From: Ken Shimko <kshimko.meridianenv@gmail.com>
Sent: Tuesday, May 01, 2018 2:45 PM
To: Stoltz, Carrie R - DNR
Subject: Jims Bar - Jump River - Change Order - 4in SVE vents, Pilot Test, addtl MW
Attachments: Change Order Pilot Test - 4in - well.pdf

Subject: Change Order:

Site: Jim's Bar
Jump River, Wisconsin
PECFA No. 54433-9769-64
DNR BRRTS No. 03-61-000116
Meridian No. 05F781

Figure
Proposed Soil Borings
Jim & Cindy's Bar
Jump River, WI

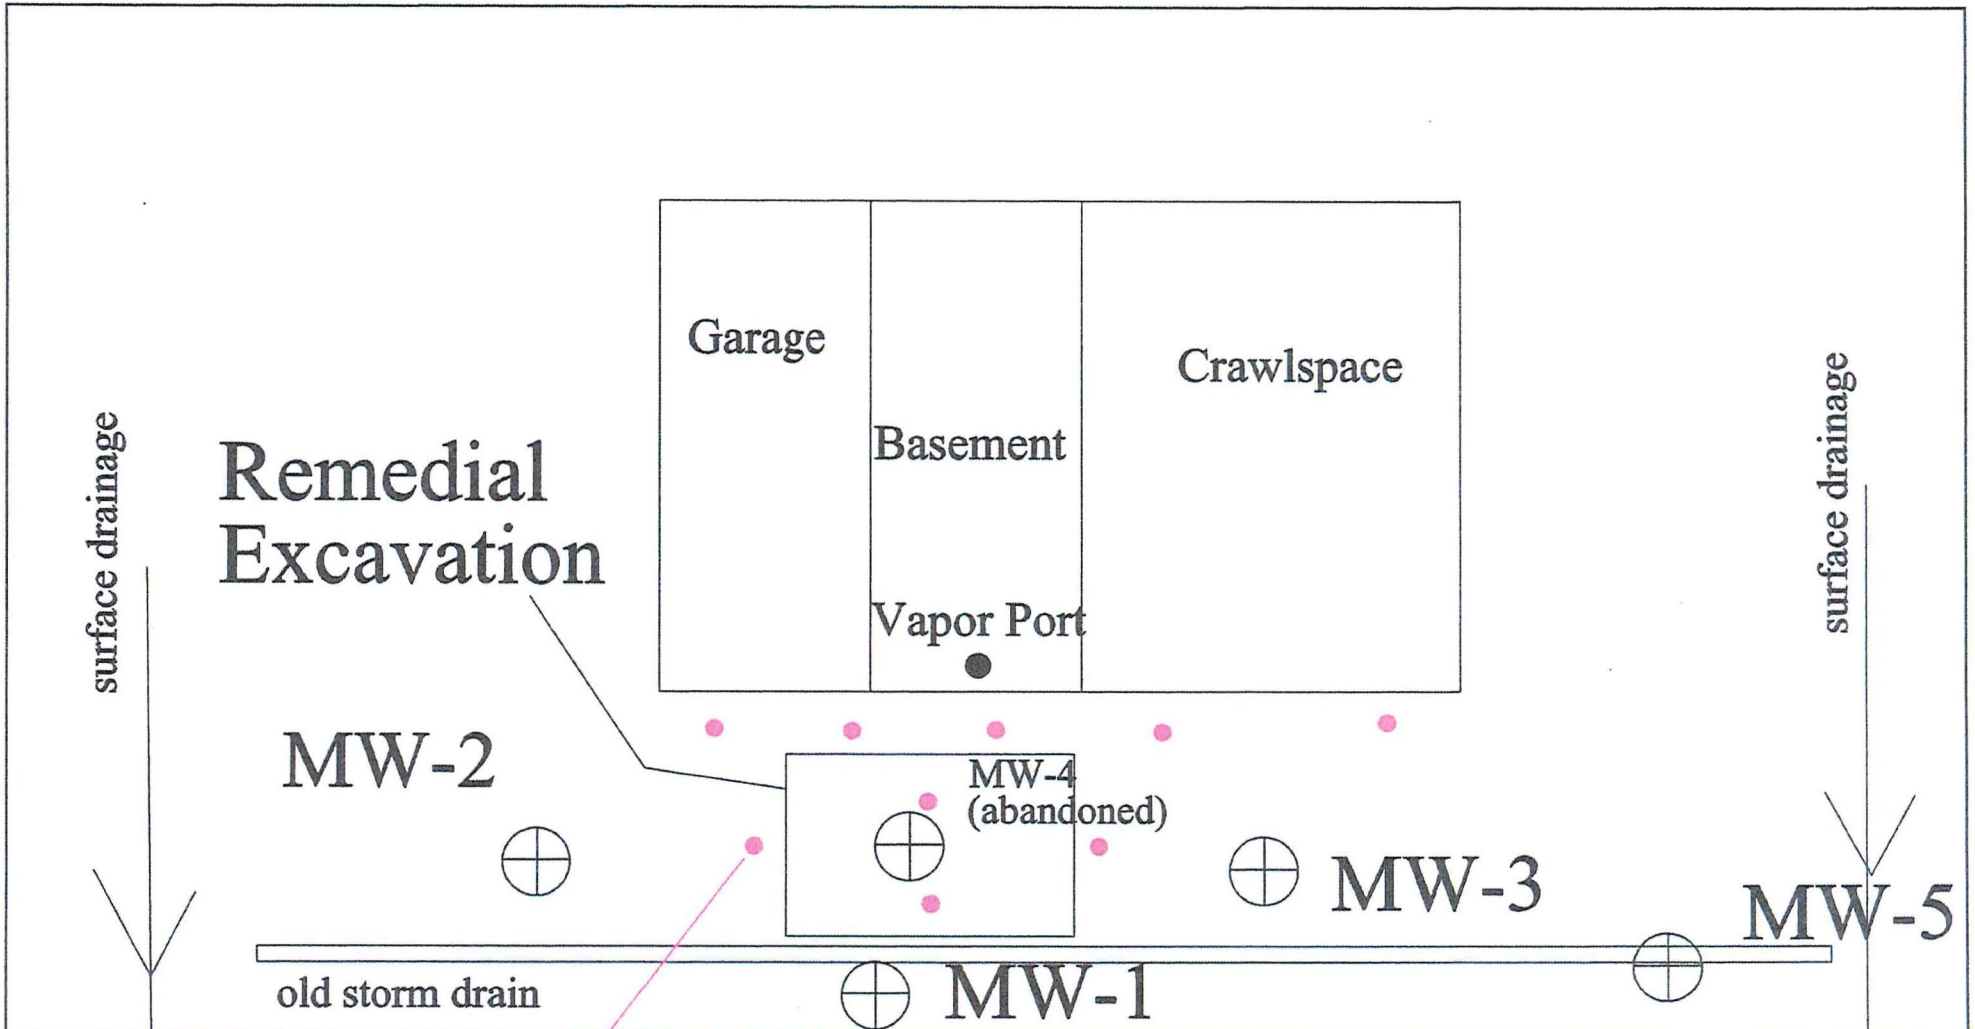
Please recall that we are planning to install monitoring wells and soil borings at this site. Attached are two diagrams which show the proposed location of the wells and soil borings.

I had proposed that we install SVE vents in the soil borings where we find impacted soil (probably around the remedial excavation). We recommend the vents be 4-inch diameter (instead of the 2-inch diameter proposed and approved in initial Change Order). This is an increased cost of \$10/foot x 6 vents x 20 ft/vent = \$1200.

Addtl well on North Side

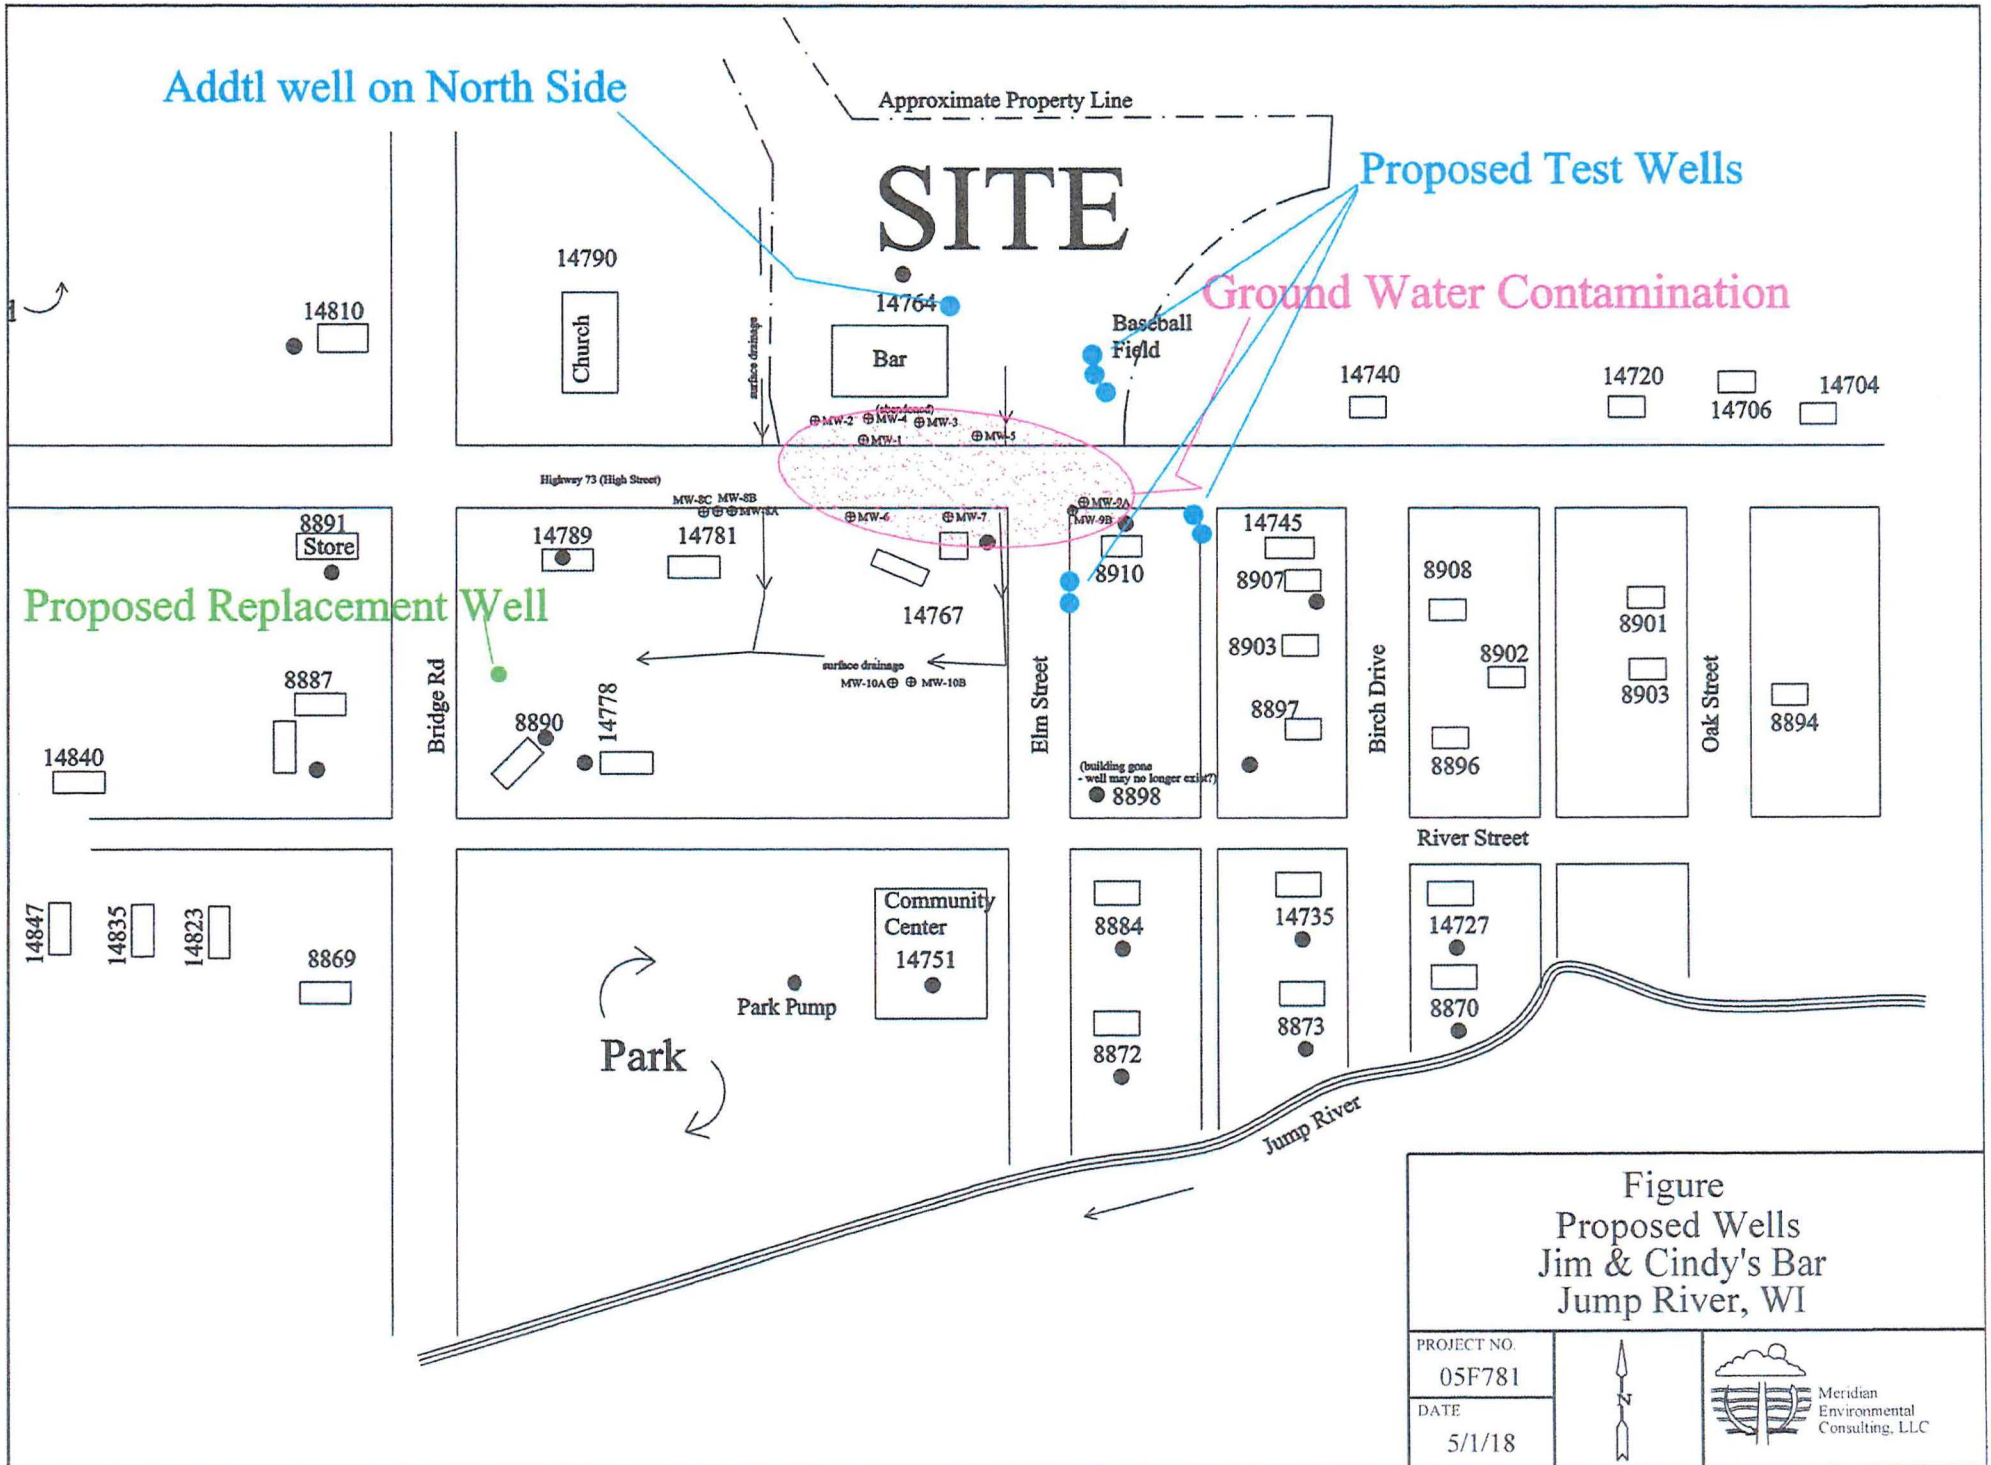
I recommend we install a monitoring well (25 ft deep) on the north side of the building. Although we do not expect ground water impacts on the north side, a clean well would be useful when we take the site to the Closure Committee.
